ADDENDUM

Addendum No.: 1

Title: Fire code Abatement Modifications/Renovations to the Yantic Fire Department, 151 Yantic Road, Norwich, CT

Responses to Requests for Information

6 TYP. BASE PL.
SCALE: 1 1/2" = 1'-0"

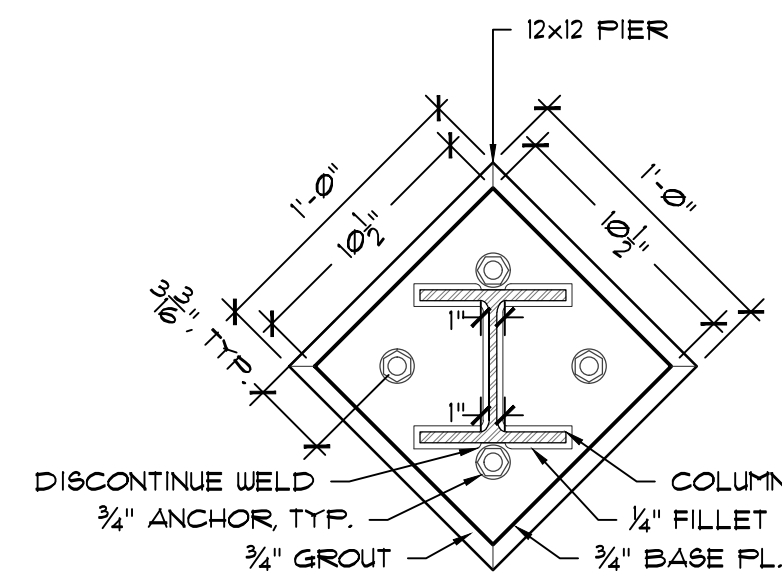
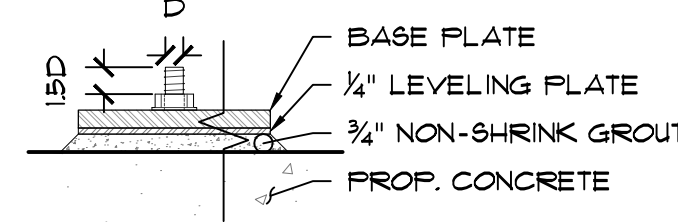
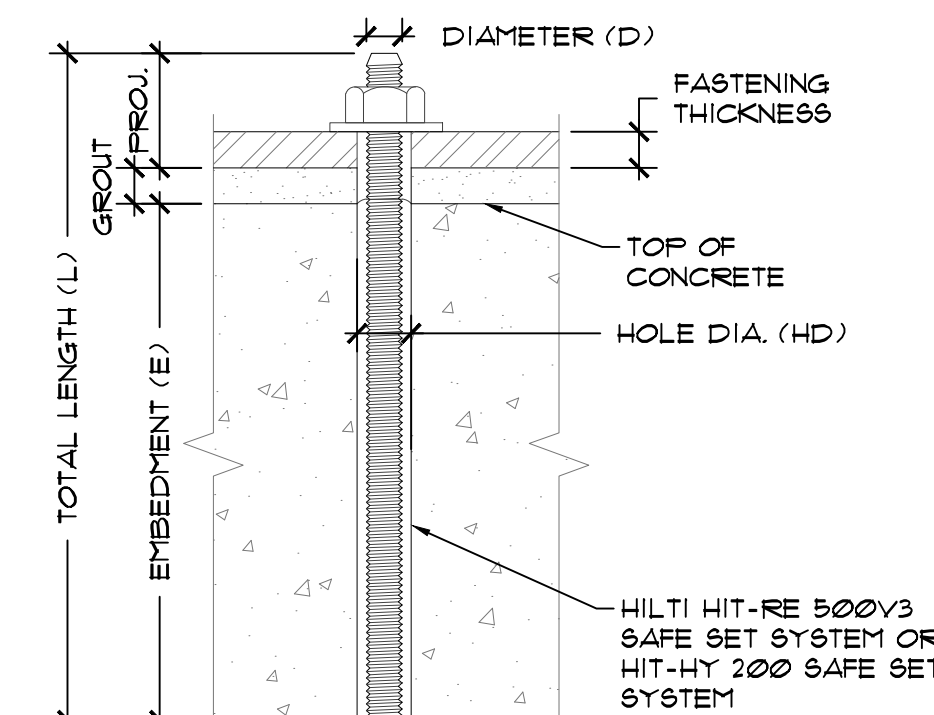
- Question 3:** What thickness base plate is required for the support columns?
Response 3: Please see Structural Drawings, particularly details 5, 6 & 7 on S-3.0: the Pier and Base Pl. details.

4 DRIFT CONNECTOR BRACKET DETAIL
 S-31 SCALE: 3" = 1'-0"

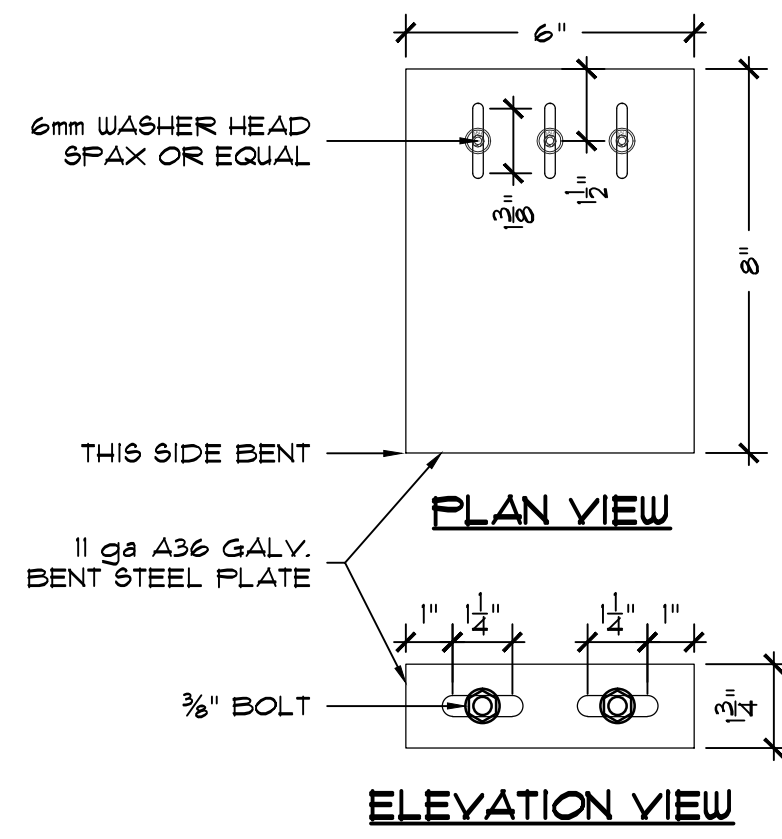
- Question 1:** Is it the intent that the balcony is free standing and not connected to building?
Response 1: Yes, the balcony is free standing, and connected only with a two way deflection clip per 4/S-3.1. Please see Structural Drawings.

6 TYPICAL COLUMN TO BE CONN. DET.
 S-31 SCALE: 1 1/2" = 1'-0"

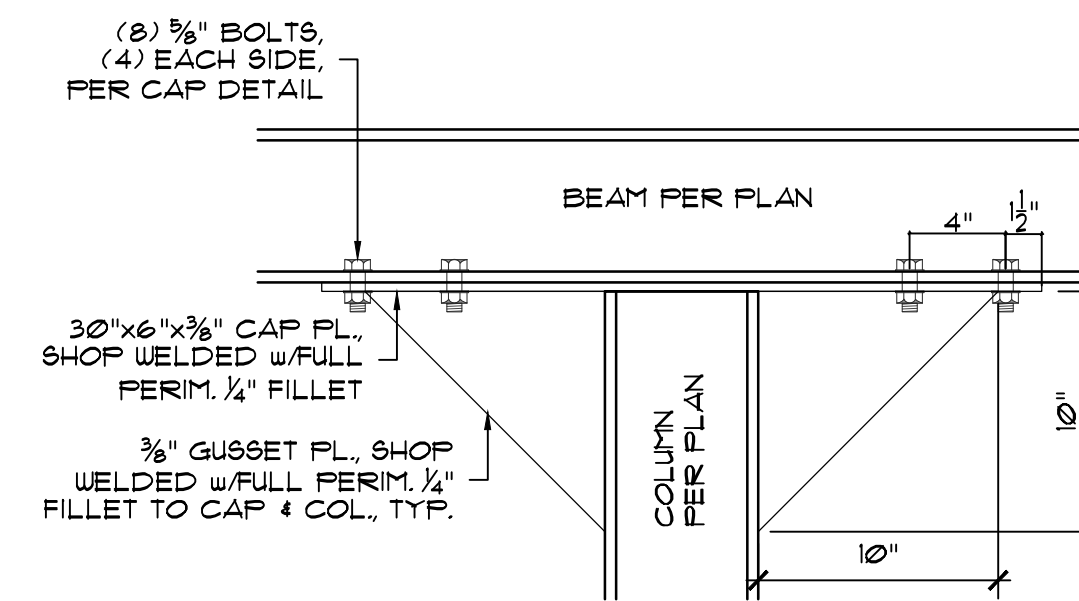
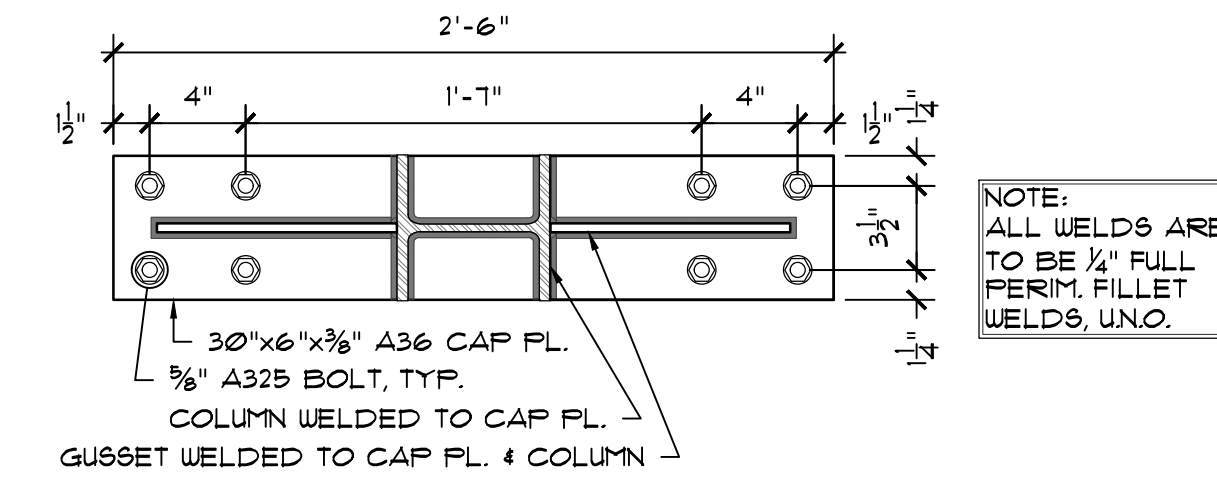
- Question 2:** What size plate and support steel is required on top of W6 columns to support the balcony and landing?
Response 2: Support per 6 & 7/S-3.1; column to beam and cap plate connection details.
